## Certified Action of the City of Raleigh Planning Commission

**Case File / Name:** SP-13-12 / Sheetz at Dixie Forest

SP-13-12 Sheetz at Dixie Forest – Site Plan

## Staff Report

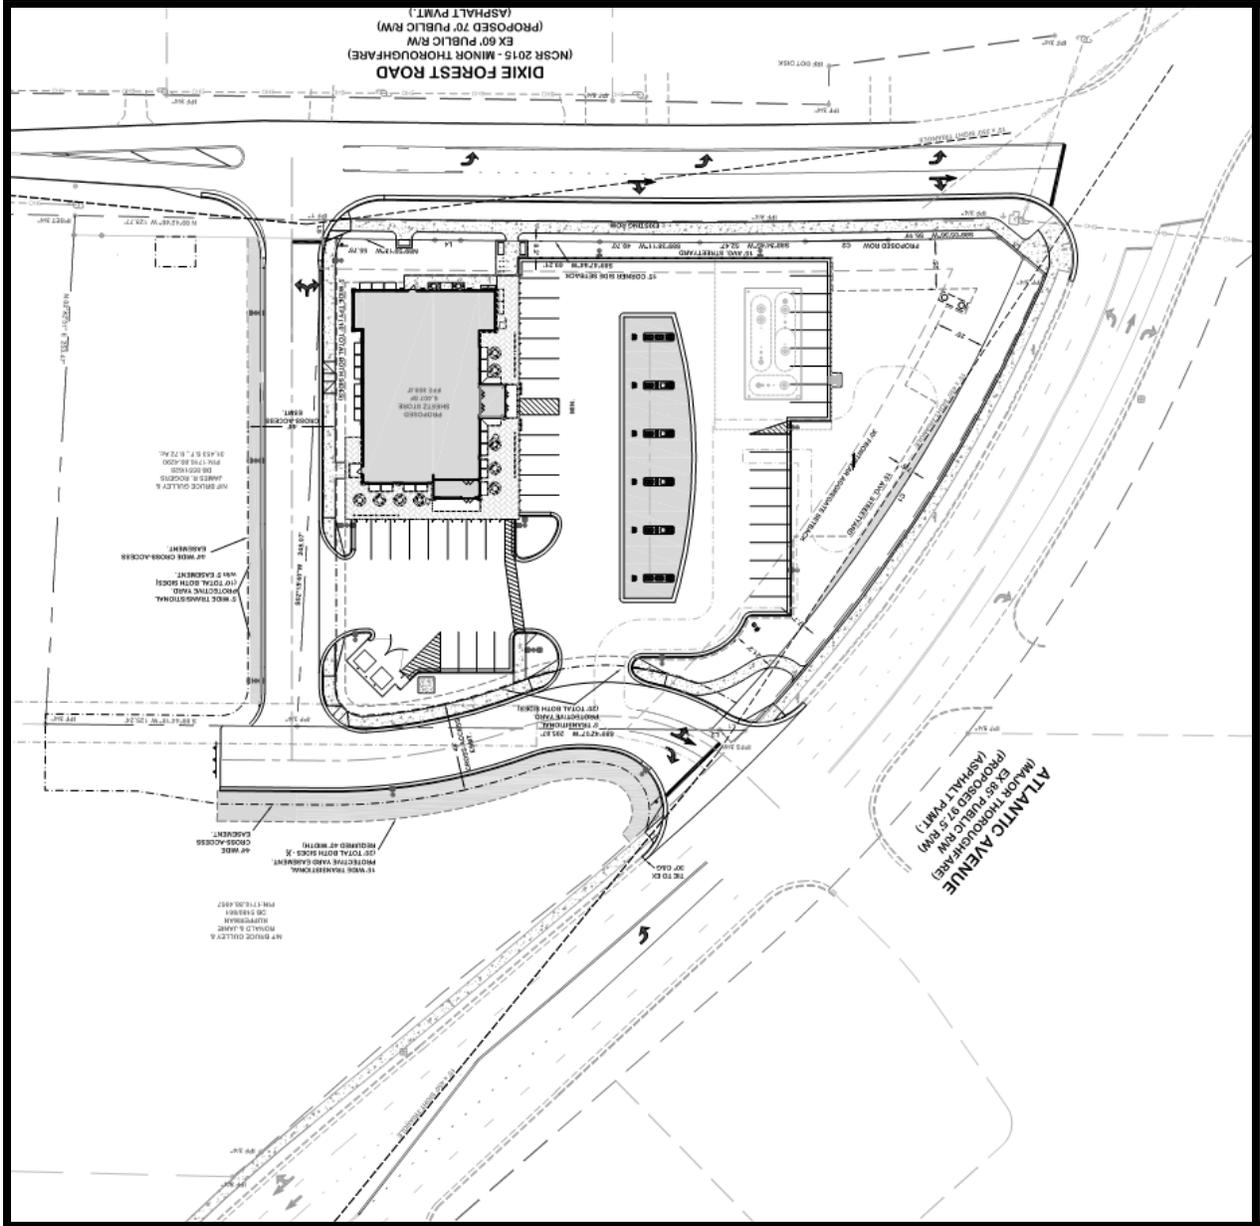
Planning Commission must approve this site plan without providing a 50' natural protective yard along Atlantic Avenue. Code Section 10-2132.2(b)(20) requires nonresidential site plans less than 2 acres in size that do not provide a 50' Natural Protective Yard to be approved by the Planning Commission.

<u>Comment</u>	<u>Response</u>
<p><b>Lights near residential-</b> Pole lights should be full cutoff, with those along the edges of the property facing residences fitted with house-side shields [commensurate with Code Sec. 10-2132.2(d)(3)].</p>	<p>Lighting plan has been provided w/ this submittal. Proposed fixtures are LED and not metal halide. With LED fixtures, there is no definition of full cutoff. However, these fixtures only project light downward and NOT upward or outward. Therefore, they simulate a full cutoff fixture.</p>
<p><b>Tree Selection-</b> Given the poor growth exhibited by red maples in restricted spaces, the Commission suggests swapping them out in favor more tolerant species (such as zelkovas or <i>Tilia</i>).</p>	<p>Maples have been removed and replaced with Silver Lindens.</p>
<p><b>Detention Pond Screen-</b> Given the visual exposure of the proposed storm water facility to the street, it is recommended that the banks be covered with shrubs of water-tolerant species [commensurate with Code Sec. 10-2132.2(d)(4)].</p>	<p>Bioretention device will be planted w/ sod and not contain plantings. I believe this comment was brought up directly as a result of the slope next to the facility and was intended more for stability. Nevertheless, planting have been provided.</p>

<p><b>Pedestrian Connectivity-</b> Enhance pedestrian connectivity between Dixie Forest [commensurate with Code Sec. 10-2132.2(d)(1) &amp; Mixed-Use Design Guidelines 10, 11, 12, 21 &amp; 26].</p>	<p>Sitting area and two, two seat tables were added adjacent to the building creating a dining area facing Dixie Forest</p>
<p><b>Show Window Treatment-</b> The</p>	<p>Illustrations were removed and colors</p>

Commission supports the use of show windows to break up facades and add visual interest. The Commission recommends that the designers 'soften glazing' treatments at Public Right of ways with something more subtle, artistic and conveying less of an overtly commercial message. [commensurate with Code Sec. 10-2132.2(d)(3) & Mixed-Use Design Guideline 25].

**Awning Treatments-** The Commission recommends that a flat awning be used to signal entry to the building from the Dixie Forest Road Side of the building. Also recommended is moving the signage to the West Corner, and providing a more modest sloped awning over the adjacent service door. [commensurate with Code Sec. 10-2132.2(d)(2) & Mixed-Use Design Guidelines 13 & 25].

were added to soften the glazing.

A flat awning was added above the door to the Dixie Forest Road entrance.
